Cumberland County Subdivision and Land Development Review Report

Municipality:	<u>Shippensburg Twp</u>	Surveyor/ Engineer:	<u>Carl Bert & Associates, Inc.</u>	Owner/ Developer:	<u>Adrian G. Martin</u>
Plat Title:	<u>Adrian Martin</u>				
Plat Status:	<u>Preliminary/Final</u>	Plat Type:	<u>Land Development</u>		
# of New Lots:	<u>0</u>	# of New Dwelling Units:	<u>0</u>	New Acreage Subdivided/Developed:	<u>1.0</u>
				Total Tract Acreage:	<u>1.9</u>
Zoning District:	<u>C-2</u>	Proposed Land Use:	<u>Vehicle Sales Lot</u>		
Date Received:	<u>4/3/2020</u>	County Review:	<u>4/9/2020</u>	Reviewed by:	<u>SH</u>
				Checked by:	<u></u>

LAND DEVELOPMENT PLAN

ADRIAN G. MARTIN

INDEX

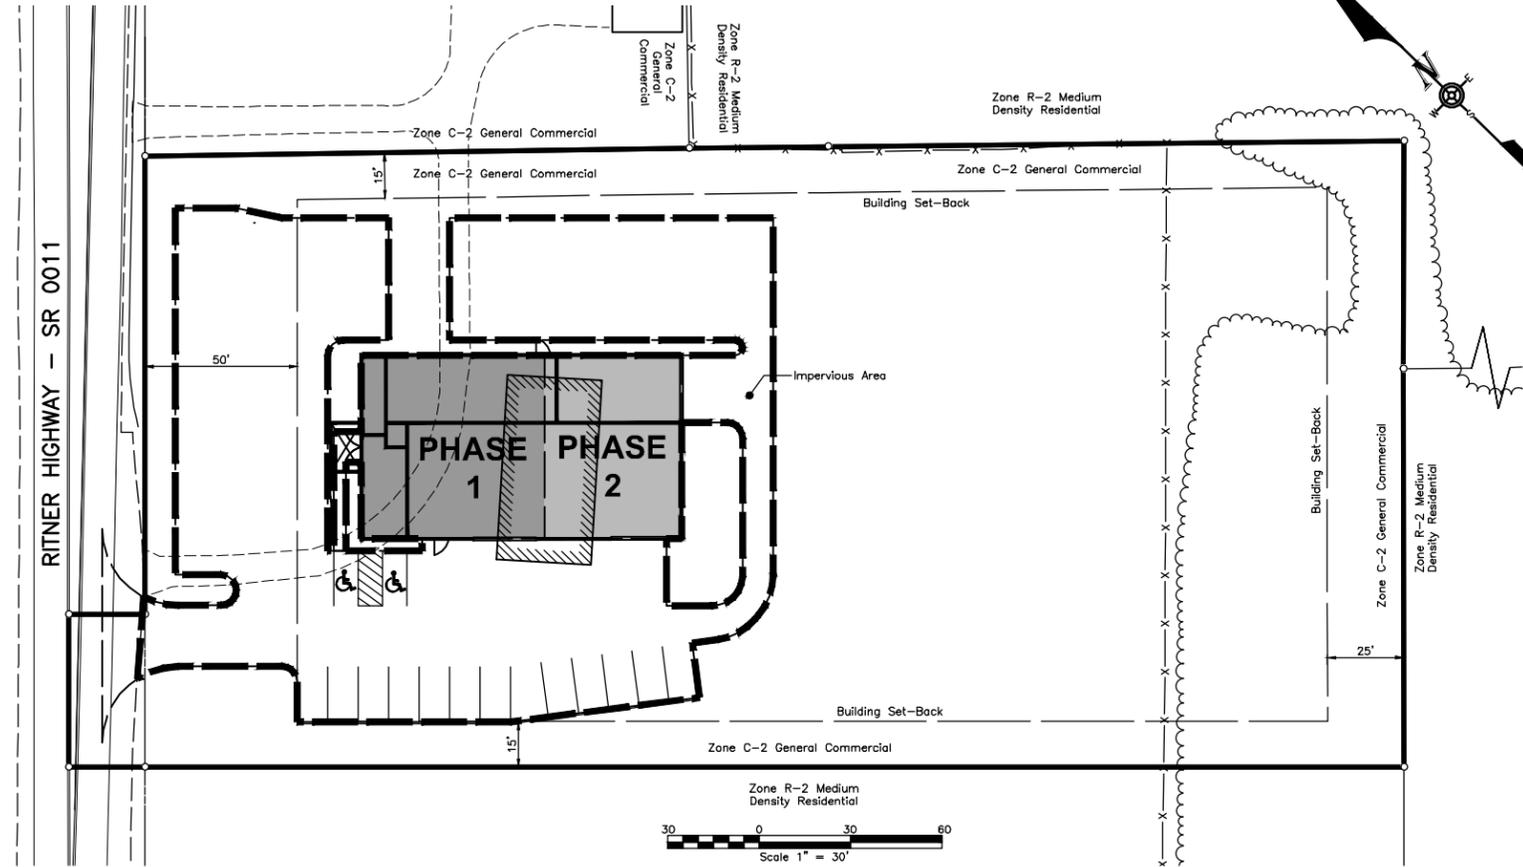
8. The Pennsylvania DEP Sewage Planning requirements should be addressed on the Cover Sheet (SLDO 600.4).

PRELIMINARY/FINAL
SURFACE / LIGHTING
SHEET 3 OF 13

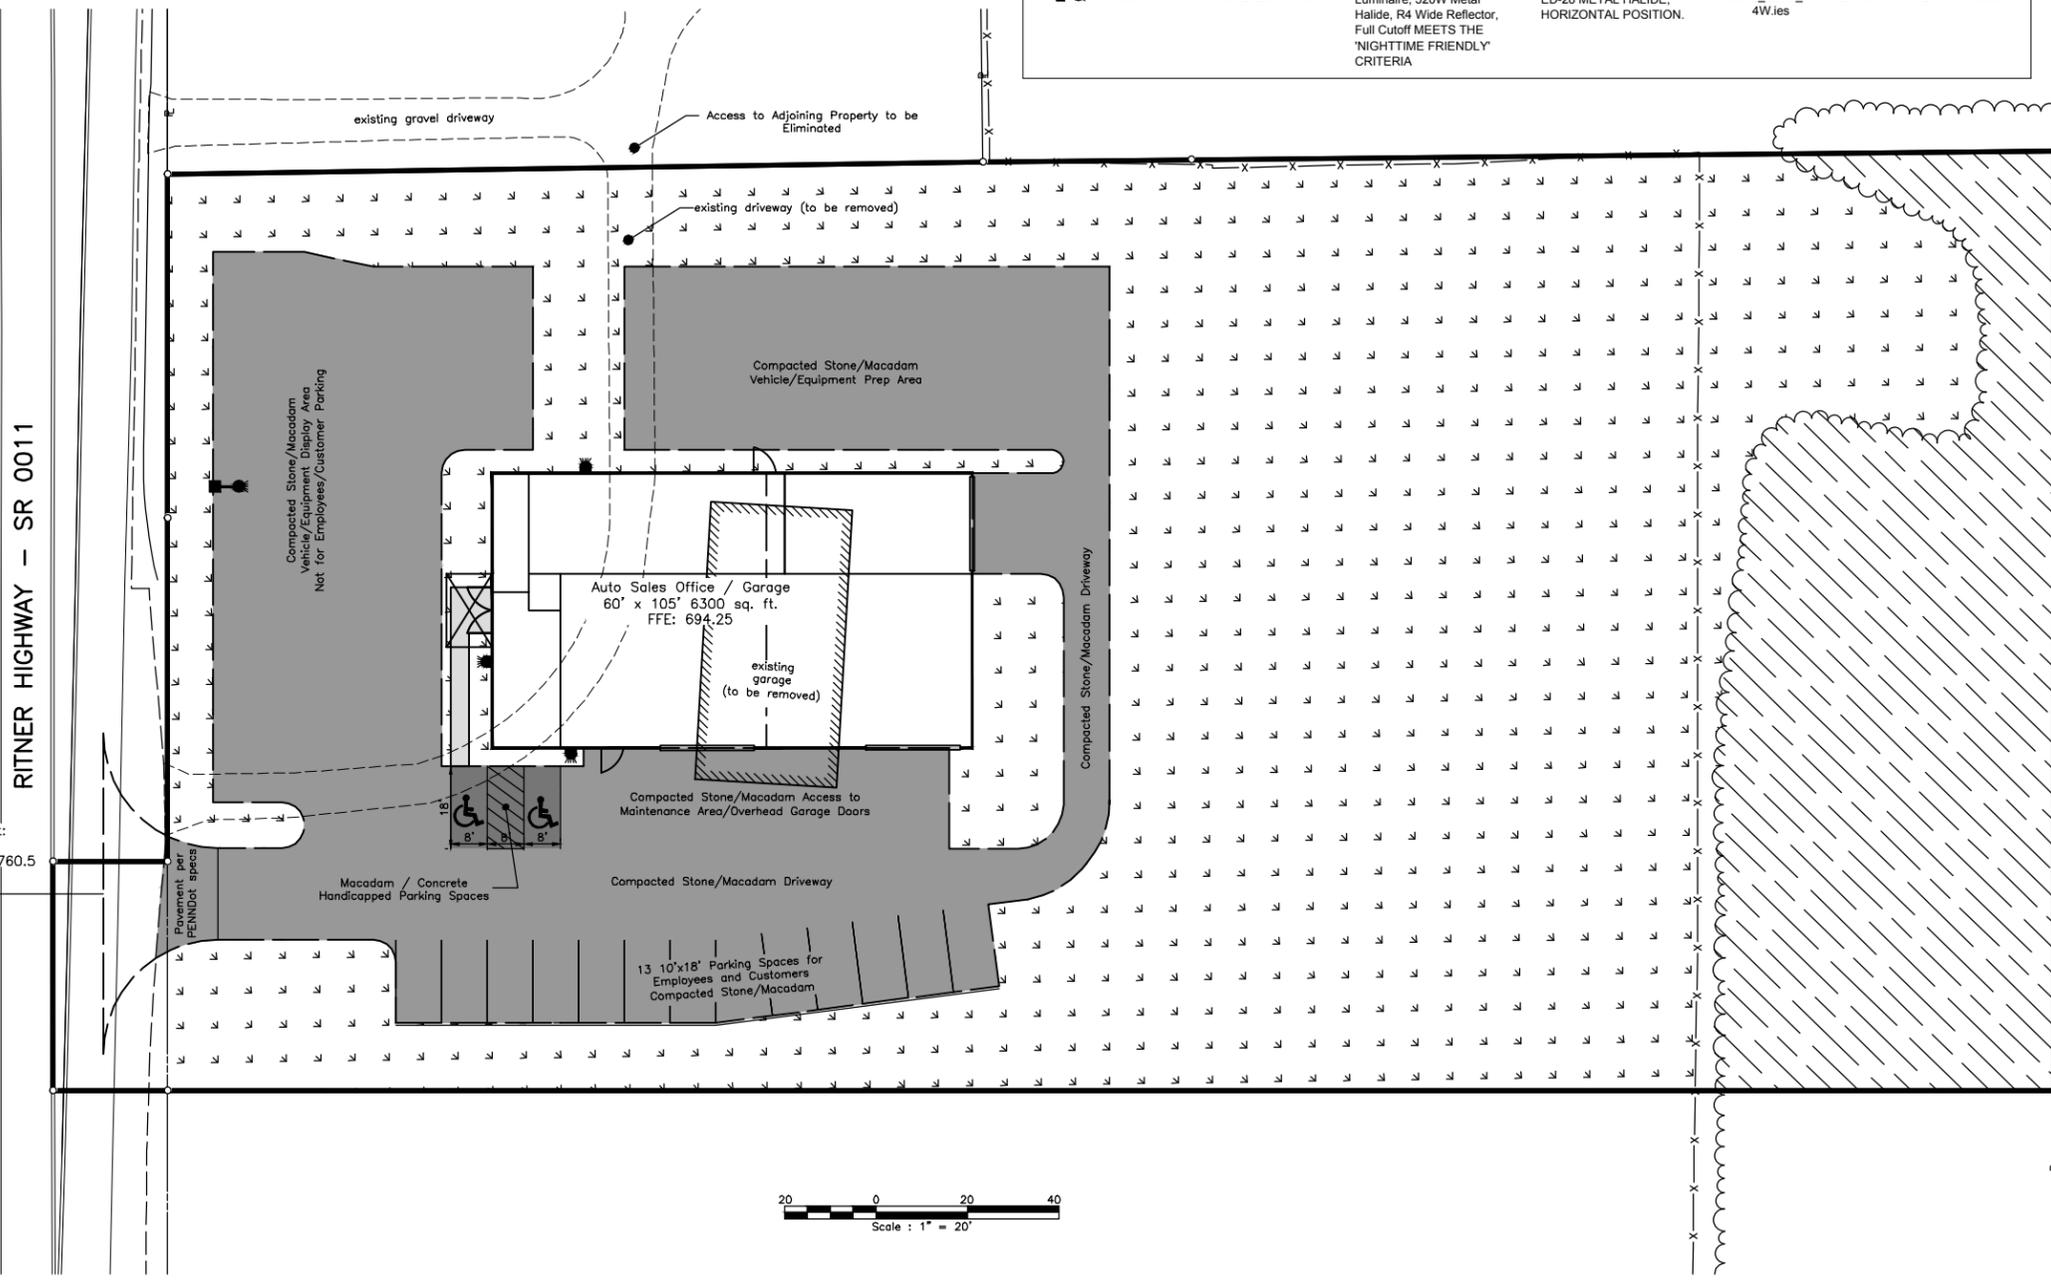
3. The plan should show the location of a proposed dumpster and include appropriate screening (Zoning 308).
4. The lighting plan (Sheet 3) should include the foot-candles on the parking lot as well as along the property lines (Zoning 317.G).

5. The parking calculations provided should be clarified. Sheet 3, Tabulation of Parking table indicates that the parking requirements are found in Section 304-II.A.2.5. The off-street parking requirements are found in Section 324 of the Zoning Ordinance. Further, the required parking spaces for a vehicle sales lot is 1 space per 15 vehicles plus 1 space per employee (Zoning 324).

9. The Erosion and Sedimentation Control Plan should be submitted to the Cumberland County Conservation District for review and approval (SLDO 600.6).
10. The applicant should verify the quantity of lighting shown on the Luminaire Schedule provided on Sheet 3.
11. When obtaining the county signature for the final plan recording process, the applicant / engineer should provide a CD that includes a .dwg AutoCAD file that shows all of the parcel boundaries, lot lines, building footprints, road rights-of-way and the edge of pavement. For more information, please visit the Cumberland County Planning Department website at: <https://www.ccpa.net/3185/Plan-Submission-Recording-Procedures>.
